Pentium® Pro Processor Specification Update

Release Date: August 1997

Order Number: 242689-020

The Pentium® Pro processor may contain design defects or errors known as errata which may cause the product to deviate from published specifications. Current characterized errata are documented in this Specification Update.

Figure 4-3. Stack Switch on a Call to a Different Privilege Level

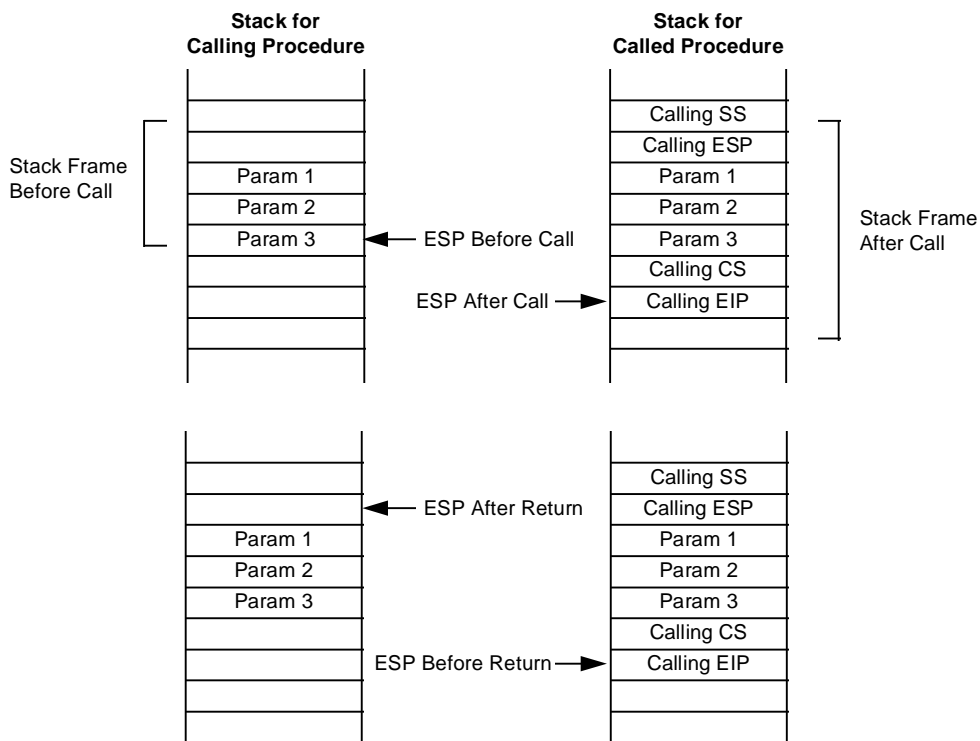
4.3.6. CALL and RET Operation Between Privilege Levels

When making a call to a more privileged protection level, the processor does the following (see Figure 4-3):

1. Performs an access rights check (privilege check).
2. Temporarily saves (internally) the current contents of the SS, ESP, CS, and EIP registers.
3. Loads the segment selector and stack pointer for the new stack (that is, the stack for the privilege level being called) from the TSS into the SS and ESP registers and switches to the new stack.

4. Pushes the temporarily saved SS and ESP values for the calling procedure's stack onto the new stack.
5. Copies the parameters from the calling procedure's stack to the new stack. (A value in the call gate descriptor determines how many parameters to copy to the new stack.)

3. (If the RET instruction has an optional *n* argument.) Increments the stack pointer by the number of bytes specified with the *n* operand to release parameters from the stack. If the call gate descriptor specifies that one or more parameters be copied from one stack to the other, a RET *n* instruction must be used to release the parameters from both stacks. Here, the *n* operand specifies the number of bytes occupied on each stack by the parameters. On a return, the processor increments ESP by *n* for each stack to step over (effectively remove) these parameters from the stacks.

4. Restores the SS and ESP registers to their values prior to the call, which causes a switch back to the stack of the calling procedure.
5. (If the RET instruction has an optional *n* argument.) Increments the stack pointer by the number of bytes specified with the *n* operand to release parameters from the stack (see explanation in step 3).

Note: On a return, parameters are released on both stacks if the correct value is given for the *n* operand in the RET *n* instruction.

Figure 4-4. Stack Usage on Transfers to Interrupt and Exception Handling Routines

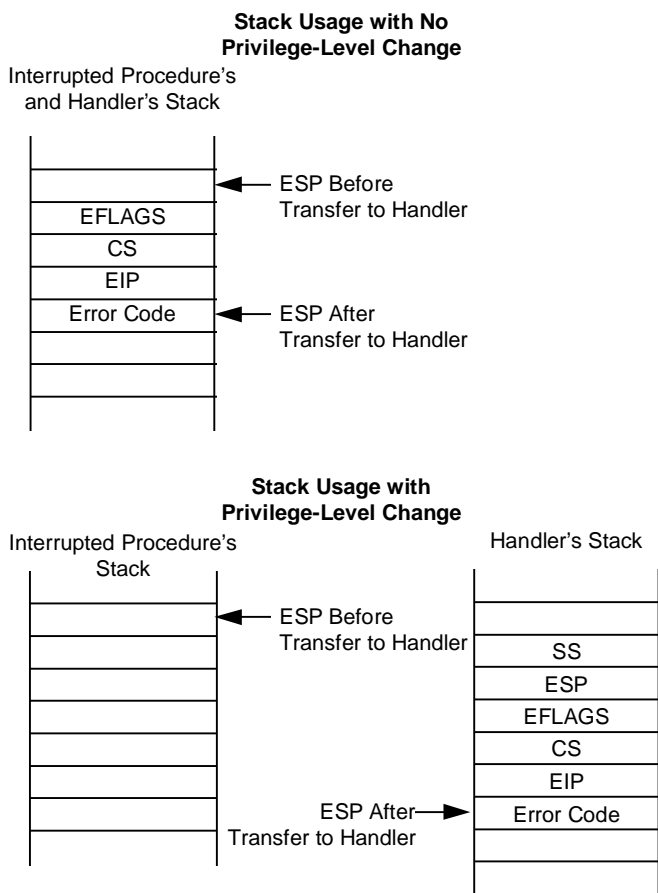
If no stack switch occurs, the processor does the following when calling an interrupt or exception handler (see Figure 44):

When executing a return from an interrupt or exception handler from a different privilege level than the interrupted procedure, the processor performs these actions:

1. Performs a privilege check.
2. Restores the CS and EIP registers to their values prior to the interrupt or exception.
3. Restores the EFLAGS register.
4. Restores the SS and ESP registers to their values prior to the interrupt or exception, resulting in a stack switch back to the stack of the interrupted procedure.
5. Resumes execution of the interrupted procedure.
